TECHNICAL BULLETIN

No: LTB00310 (ISSUE 2)
20 SEPTEMBER 2010

RANGE ROVER

Air Suspension System - New Height Sensor Availability

Figure 1

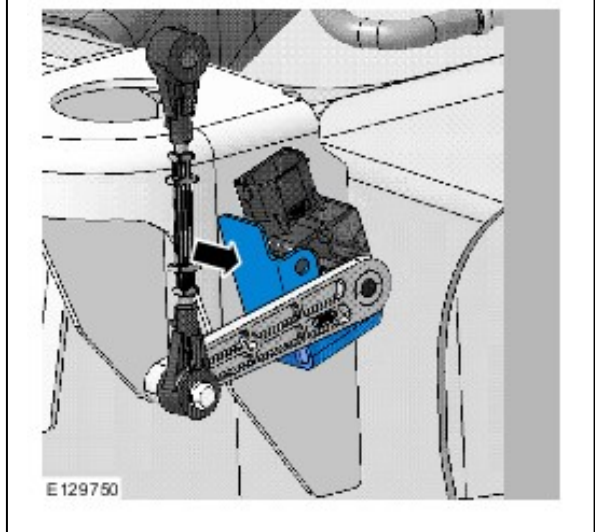
1. Inspect ride height sensor bracket position for orientation. (Figure 1)

Figure 2

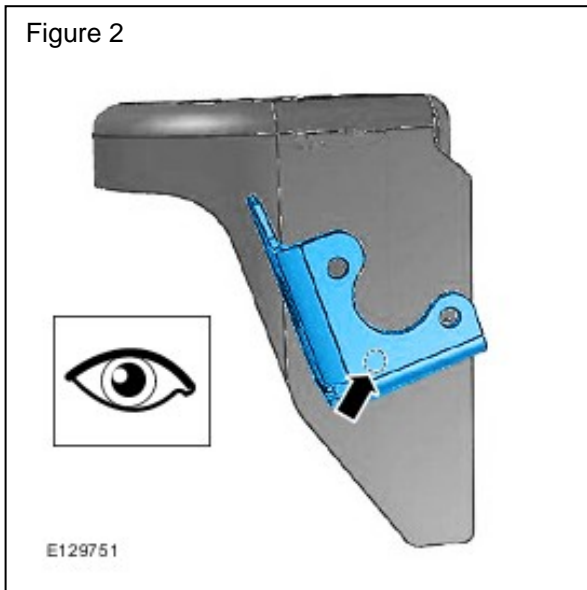
CAUTION: The bracket shown in Figure 2 may have two or three holes. It is important that the orientation of the bracket is noted and not the number of holes.

- If the orientation of the left-hand rear (LHR) ride height sensor bracket is the same as Figure 2, continue to step 3.
- If the orientation of the LHR ride height sensor bracket is not the same as Figure 2, continue to step 2.
- If the ride height sensor bracket is installed as shown in Figure 3, continue to step 2.

Figure 3

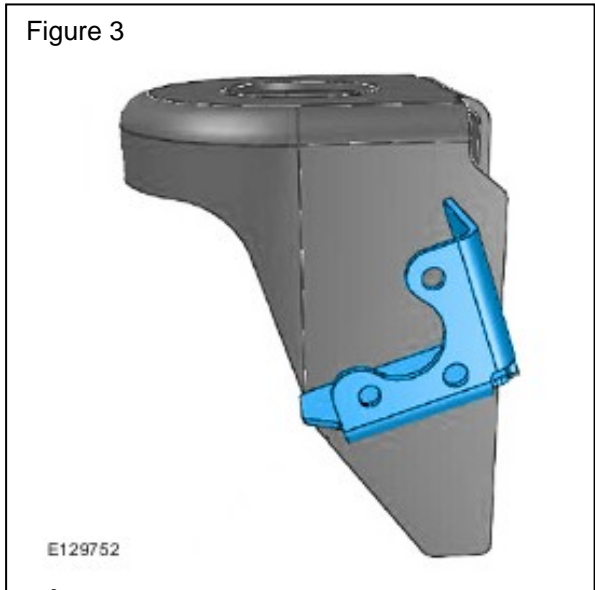
NOTE: This condition affects only a small number of chassis frames of vehicles built at the end of 2009.

Figure 4

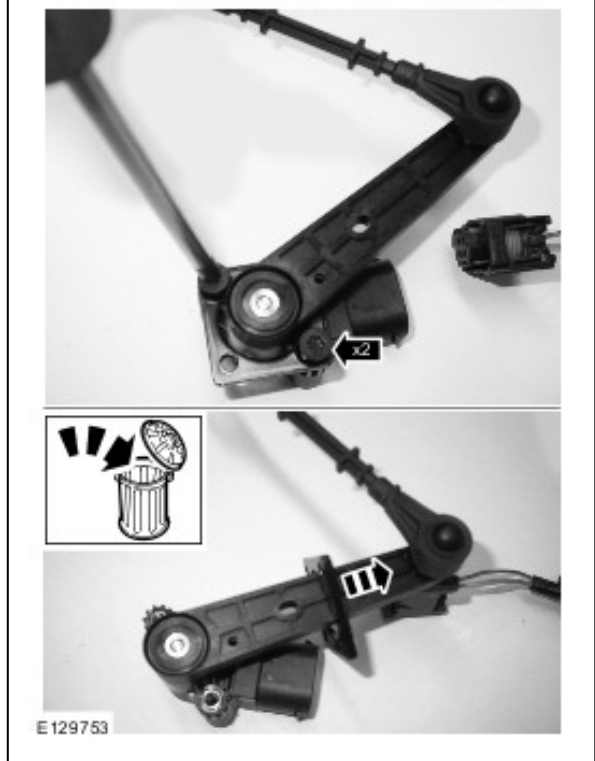
2. Remove the bracket from the new ride height sensor:
(Figure 4)
 - Remove the two screws.
 - Discard the bracket.

Figure 5

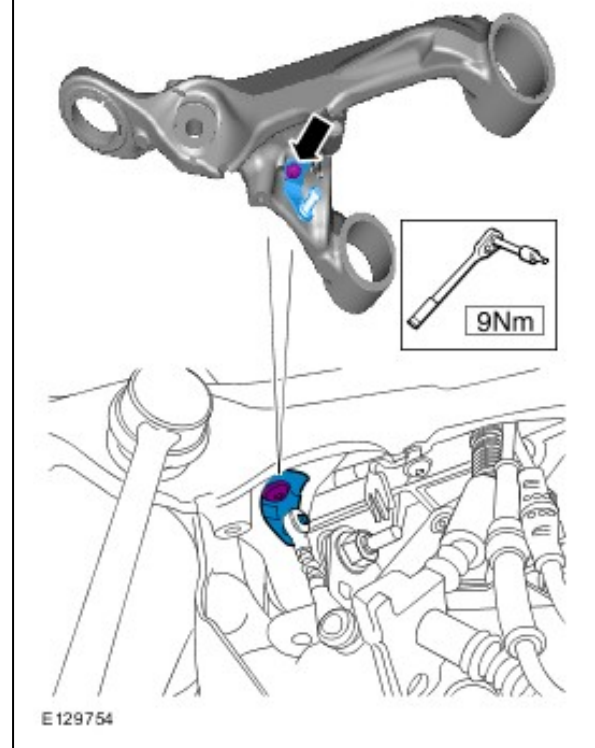
- Remove and discard the sensor link pin from the upper arm. (Figure 5)
- Install the new sensor link pin to the upper arm.
- Tighten bolts to **9Nm (6.6lbf ft)**.
